SUBJECT: H. B. ROBINSON STEAM ELECTRIC PLANT, UNIT NO. 2 - ISSUANCE OF  
AMENDMENT NO. 271 REGARDING CORRECTION TO NON-  
CONSERVATIVE TECHNICAL SPECIFICATIONS FIGURE 3.4.3-2,  
PRESSURE/TEMPERATURE LIMIT COOLDOWN CURVES  
(EPID L-2021-LLA-0223)

Amendment No. 271  
Renewed License No. DPR-23

SAFETY EVALUATION BY THE OFFICE OF NUCLEAR REACTOR REGULATION

Figure 3.4.3-2  
Reactor Coolant System Cooldown Limitations  
Applicable Up to 46.3 EFPY

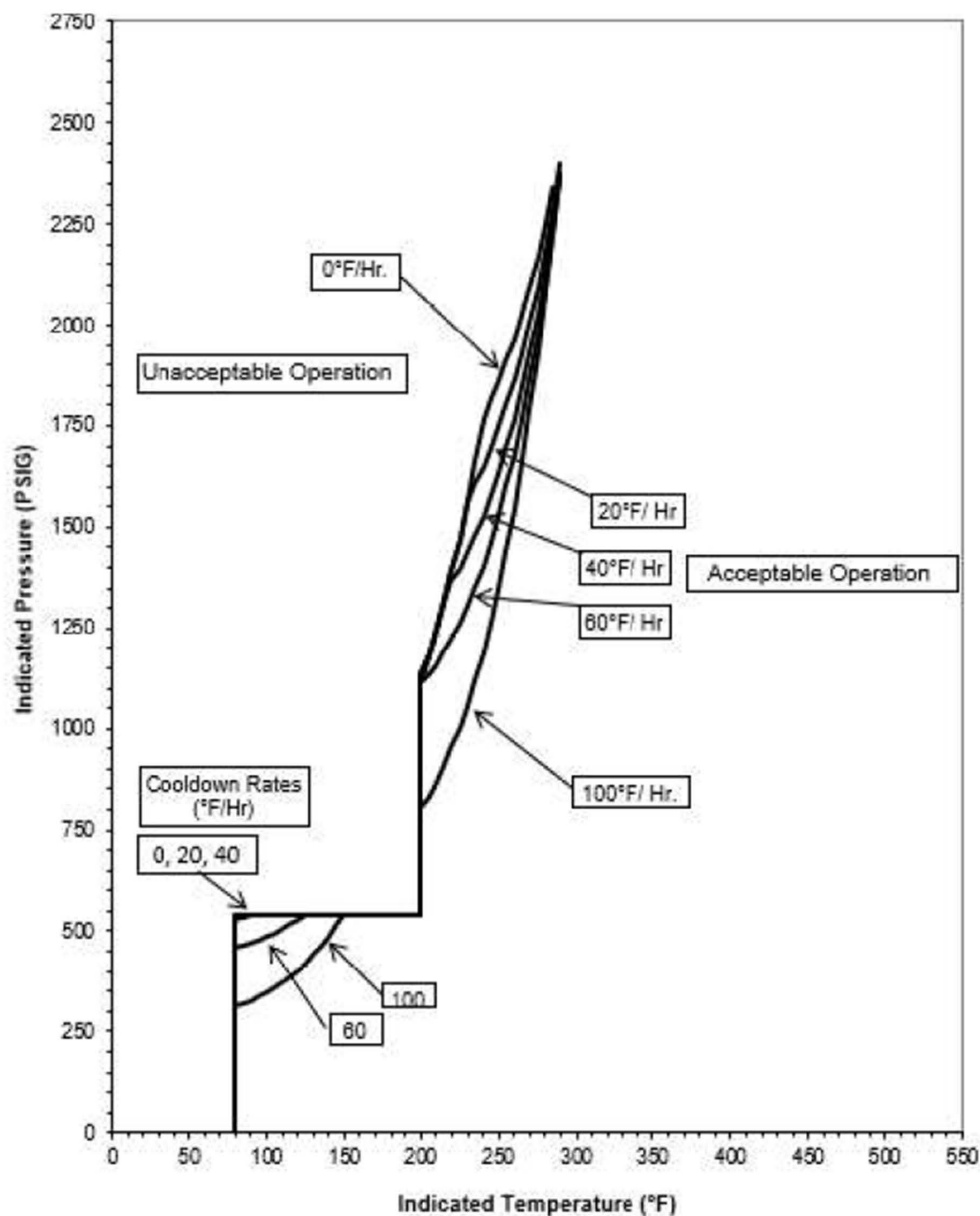
The licensee identified that a portion of TS Figure 3.4.3-2 is non-conservative and does not

reflect the P/T limit data approved in Amendment No. 248. The licensee explained that a portion of TS Figure 3.4.3-2 is being corrected to match the approved P/T limit data. Specifically, the portion of TS Figure 3.4.3-2 being corrected is the 60°F/hr and 100°F/hr cooldown curves at temperatures below 150°. The licensee stated that data from historical plant cooldowns since implementation of the incorrect P/T limit curve figure was reviewed and it was determined that the approved P/T limits in Amendment No. 248 were not violated.

The following example illustrates the correction needed to Figure 3.4.3-2. The NRC staff noted that the stated values include the +20°F and -80 pounds per square inch gauge (PSIG) adjustment for instrumentation error on top of the data in Table 28 of WCAP-15827. It can be seen from Table 28 of WCAP-15827 that the 100°F/hr curve should start its downward trajectory from 541 PSIG at 150°F, but the current TS Figure 3.4.3-2 shows it starting at approximately 145°F. Similarly, the 60°F/hr curve should start its downward trajectory from 541 PSIG at 125°F, but the current TS Figure 3.4.3-2 shows it starting at approximately 115°F.

The licensee proposed change in the current submittal revises the 60°F/hr and 100°F/hr curves in TS Figure 3.4.3-2 to reflect the data in Table 28 of WCAP-15827.

Cooldown Curves for Robinson. Further, the NRC staff confirmed that TS Figure 3.4.3-2, as proposed in the LAR, accurately reflects the data in Table 28 of WCAP-15827, the use of which the NRC previously approved in Amendment No. 248 and Amendment No. 260. Accordingly, the NRC staff concludes that proposed TS Figure 3.4.3-2 is acceptable.
